Traffic and Site Access Study

Case 15ZONE1070 March 1, 2016

Review of Applicants Traffic Impact Studies – Mar 2 &17

Traffic Exit Avish Garden to Hwy 22

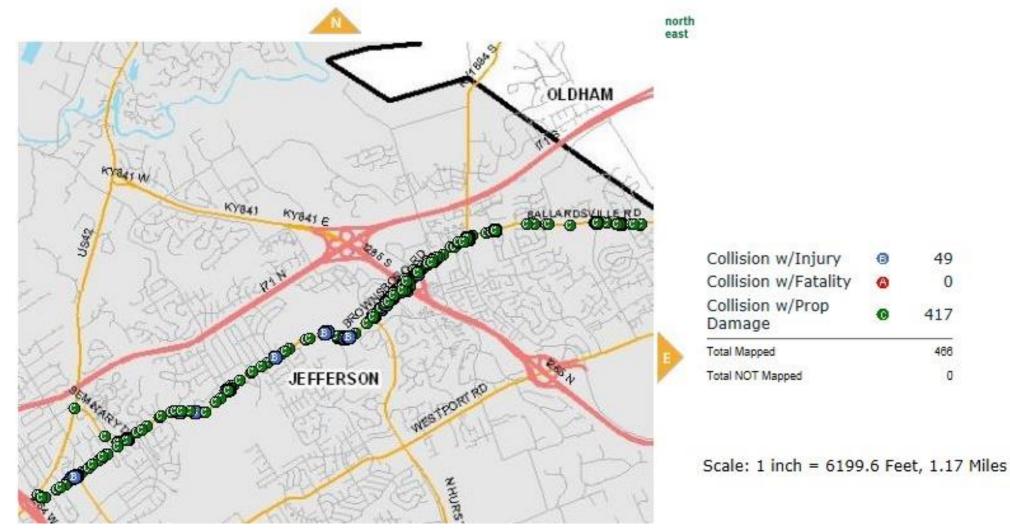
Only access to Hwy 22 with a traffic signal

Exit Rd is 167 Ft

Collisions Hwy 22 from I-264 to Oldham Cty line – Jan 2014 to May 2016

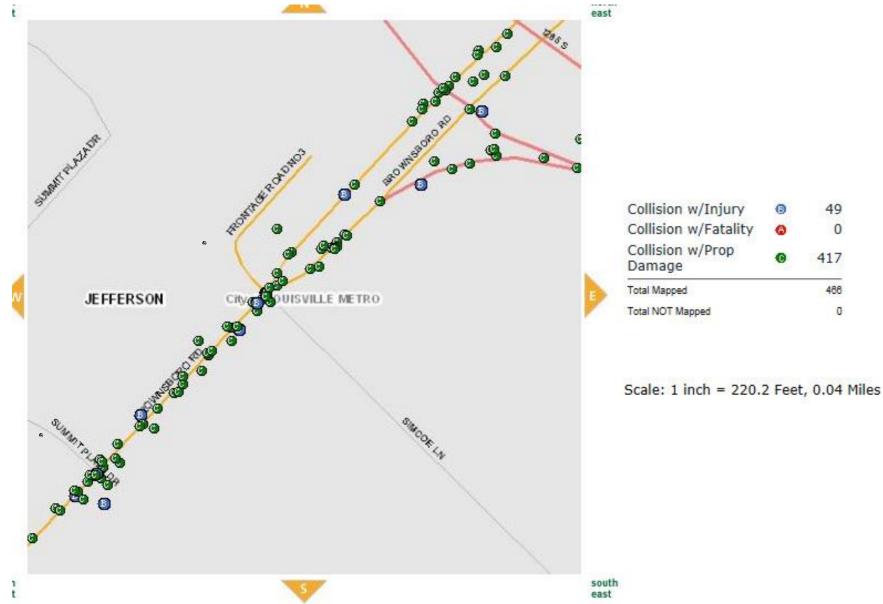
456 total collisions, average one collision every 44 Hrs

Traffic VPD* Hwy22 @ Simcoe

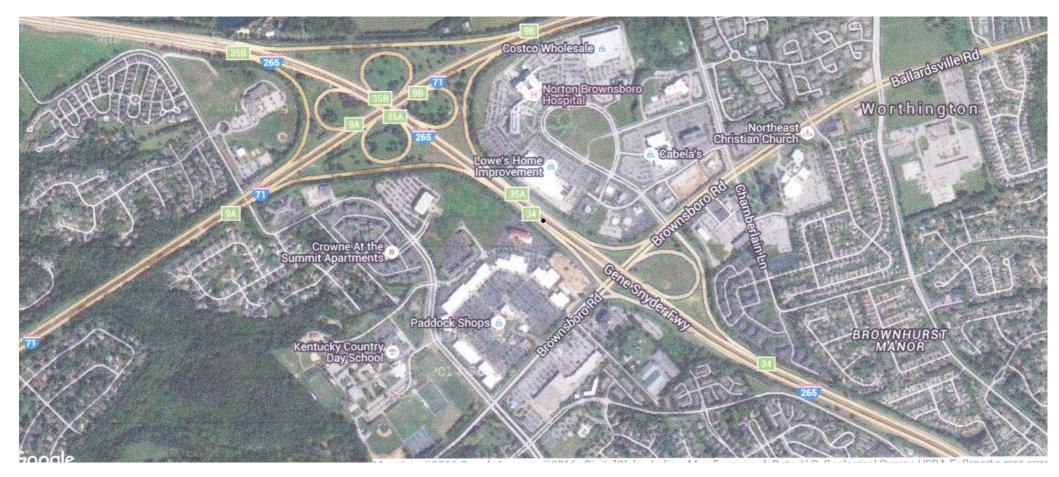
- 33,000 VPD (est) 5.4%/Yr Growth
- 34,980 VPD Projected @ 2% Growth
- 38,346 VPD Projected at present growth rate of 5.4%/YR

Due to continued development along the Hwy 22 corridor to Oldham Cty, we believe the actual VPD will likely exceed 6% annual growth
